FINAL DECISION DOCUMENT
FOR THE
GROUND-WATER INTERCEPT AND TREATMENT
SYSTEM NORTH OF ROCKY MOUNTAIN ARSENAL
INTERIM RESPONSE ACTION

July 1989

Prepared for:
U.S. ARMY PROGRAM MANAGER'S OFFICE FOR
ROCKY MOUNTAIN ARESENAL CONTAMINATION CLEANUP

Figure 1-2
IRA STUDY AREA

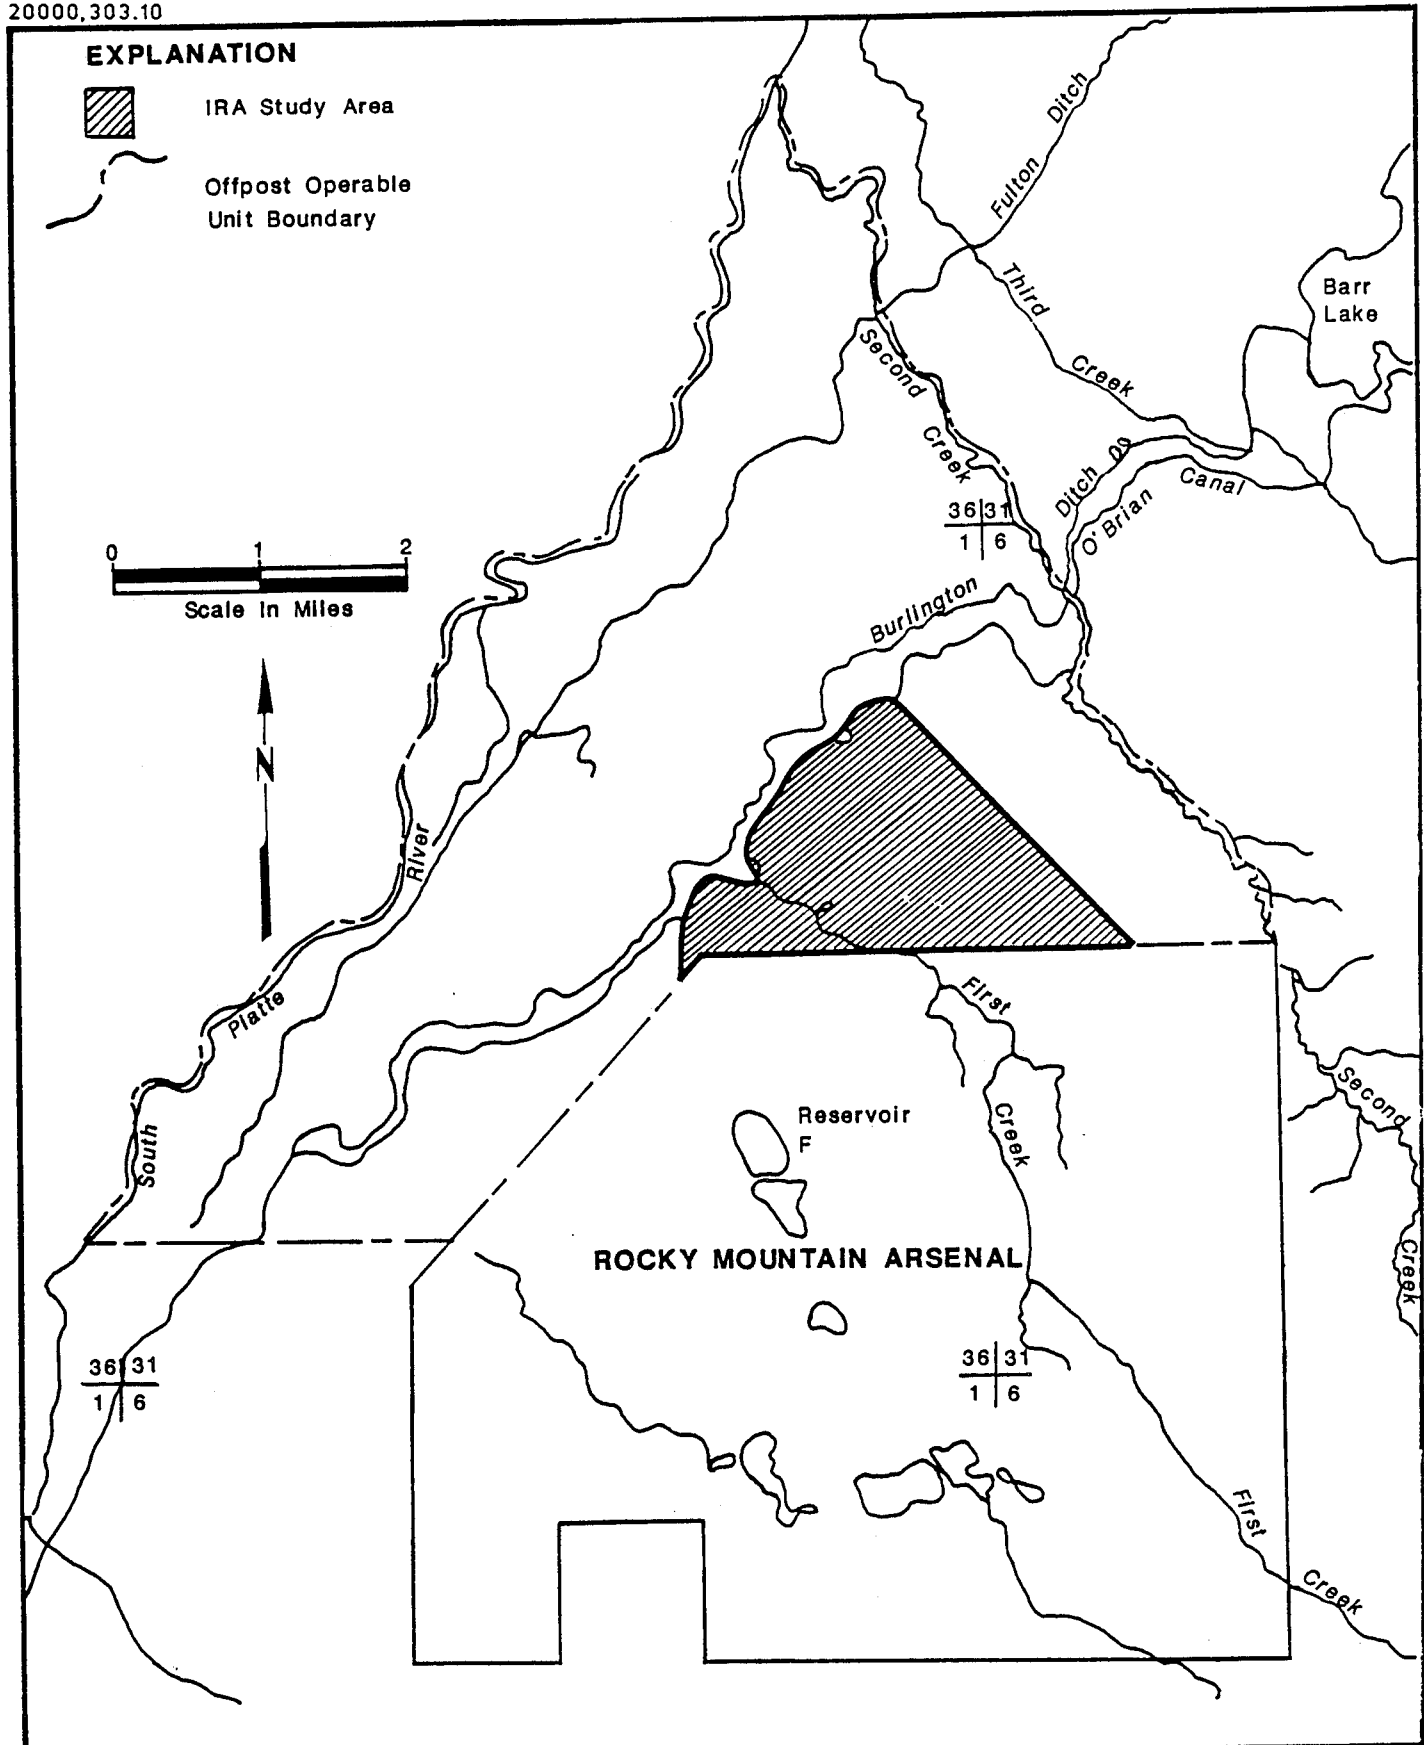
Pp. 2-3 and Figure 1-2. The study area is too restrictive to meet all of the objectives of this interim action. The State concurs that the groundwater intercept and treatment systems should be sited within the bounds of the proposed study area. However, RMA contaminants are known to exist in the ground water as far north as the South Platte River. Therefore, the study area must be expanded to include all off-post areas which may require alternate water supplies and/or monitoring.

The study area shown defines the area within which the ground-water intercept and recharge system will likely be located. The need for alternative water supplies over a broader area is being reviewed in the Offpost EA/FS. The document has been revised to indicate the current alternative water supply program, outside the scope of this IRA, will be continued and an alternative water supply will be provided immediately if a well is found to contain RMA-derived contaminants above established health criteria.

Figure 2-2
UNSATURATED ALLUVIUM AND PRIMARY
FLOW PATHS IN VICINITY OF IRA
STUDY AREA

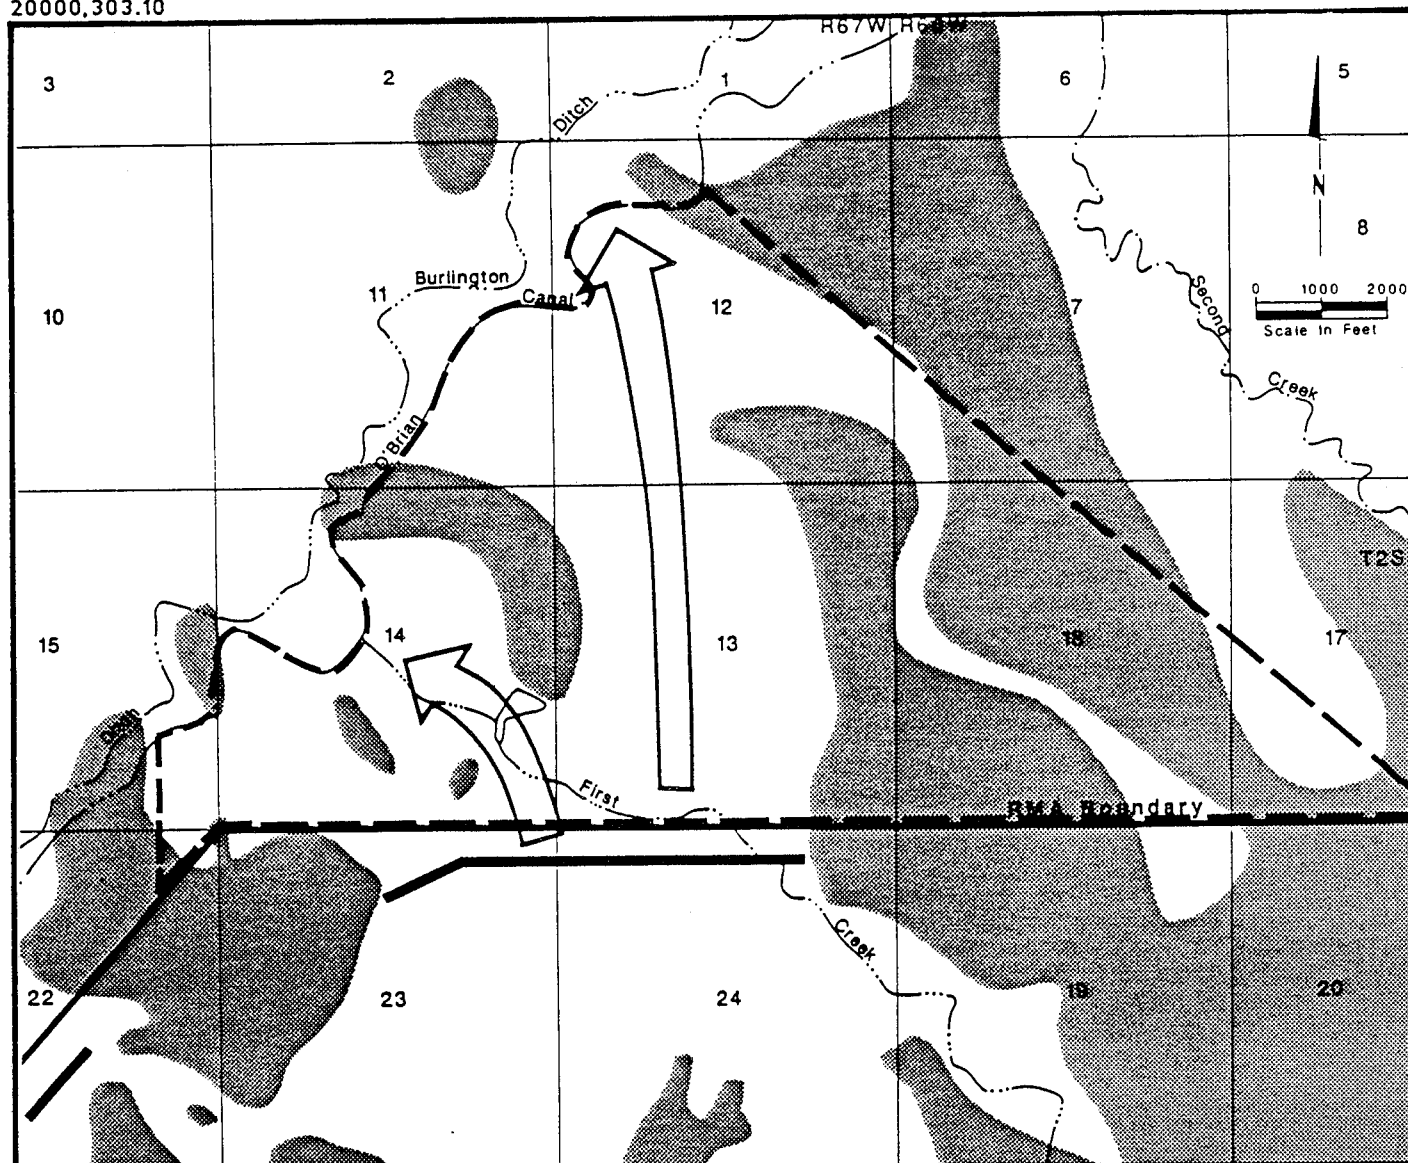
The primary groundwater flow path towards the North Boundary Containment System does not go through Section 23 as implied by the location of the arrow on the figure. A much larger groundwater flow migrates towards the boundary system through Section 24, near First Creek.

The figure has been modified in response to this comment.
